6.2 376-384 ST KILDA ROAD MELBOURNE

PREPARED BY: SCOTT PARKINSON, PRINCIPAL PLANNER

1. PURPOSE

- 1.1 To consider and determine Planning Permit application 764/2020 for buildings and works to an existing commercial building associated with a food and drinks premises, office, and supermarket (no permit required for use) and reduce the car parking requirements at 376 - 384 St Kilda Road, Melbourne.

Figure 3 - Proposed front setbacks to St Kilda Road

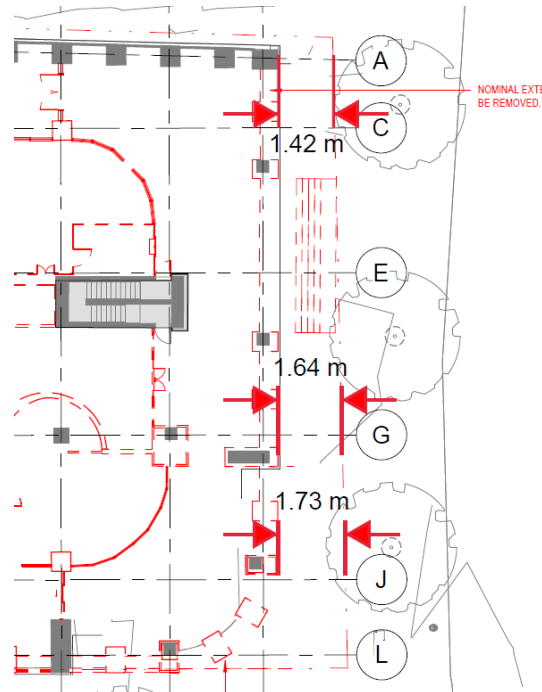
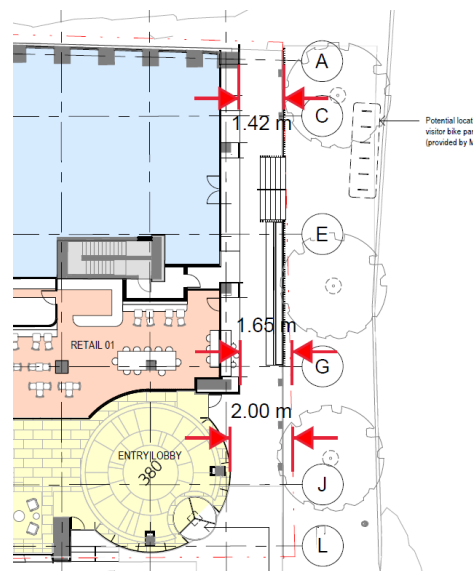
Council considers the revised treatment to the existing reduced setback (i.e the non-compliance) to be successful in achieving the design objectives of the DDO26. It would positively improve the streetscape response, improve activation, and surveillance and would represent design excellence.

In this instance the reduced setback is supported and permitted under Clause 4.0 of the DDO26.

Proposed loading bay with reduced depth

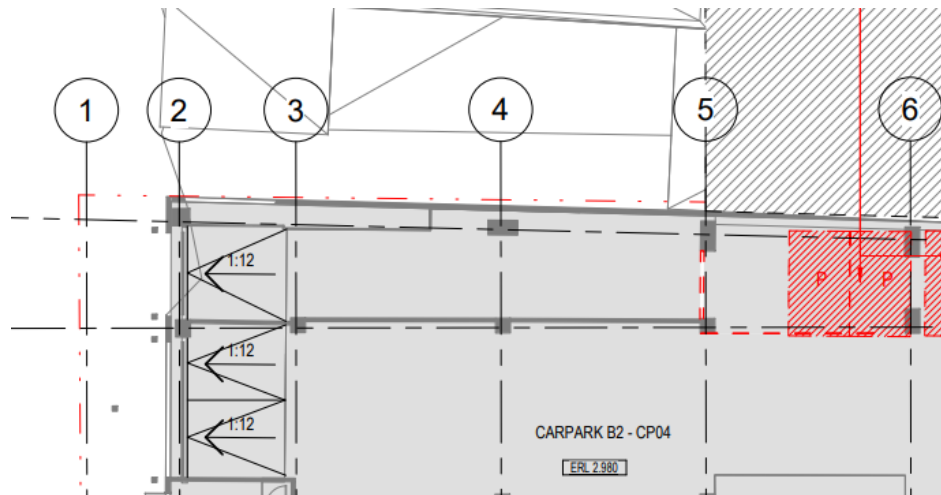
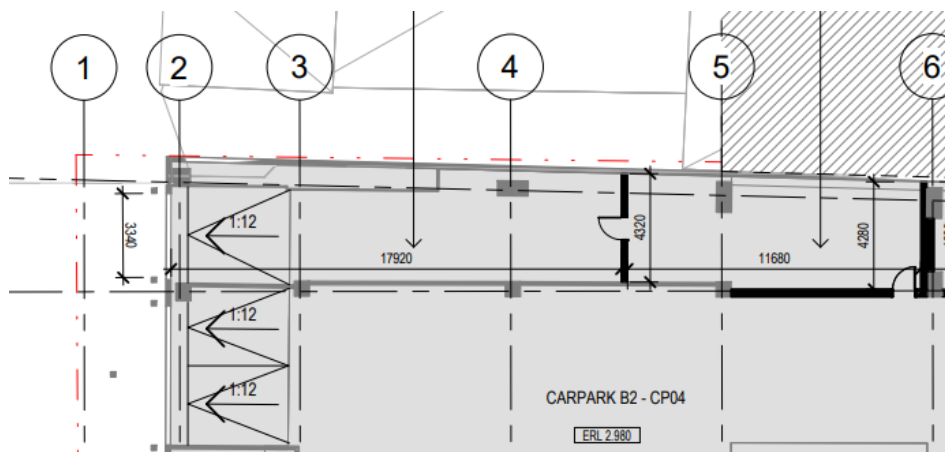
- Varied loading facility capability as a result of reducing the depth of the existing loading facility as per Figure 5 and Figure 6 below.

Figure 7 - Swept path diagram for southbound Wells Street vehicles

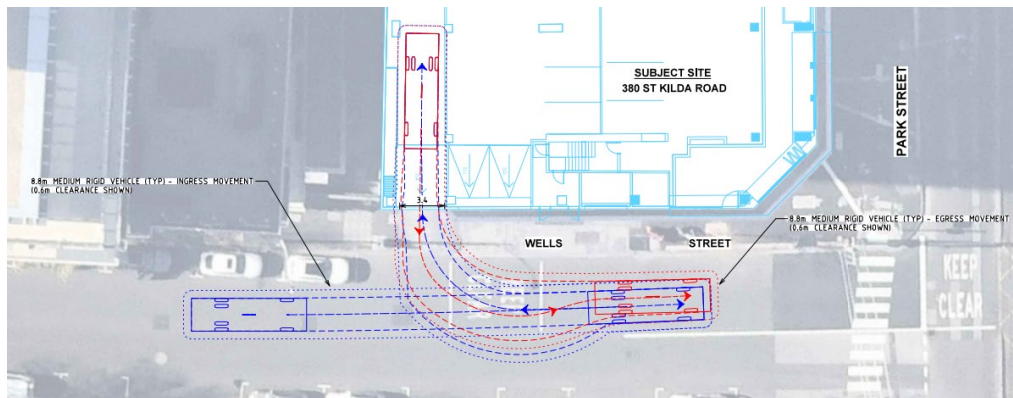
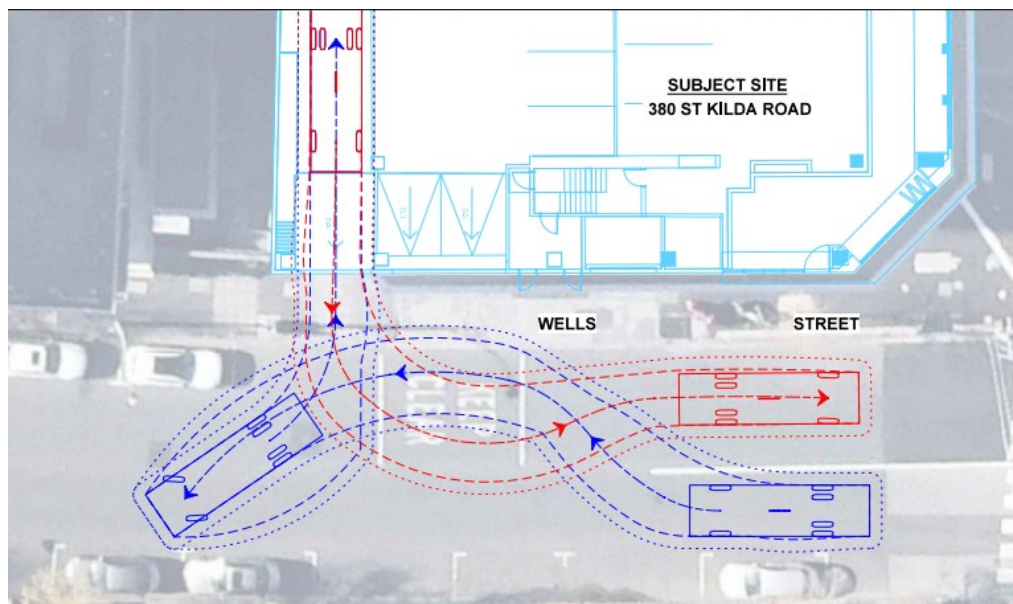
Swept path diagrams have been provided which confirm access can be provided for medium rigid vehicles via reverse in and forward out which does not require the full depth of the loading bay as per Figure 7 and Figure 8.
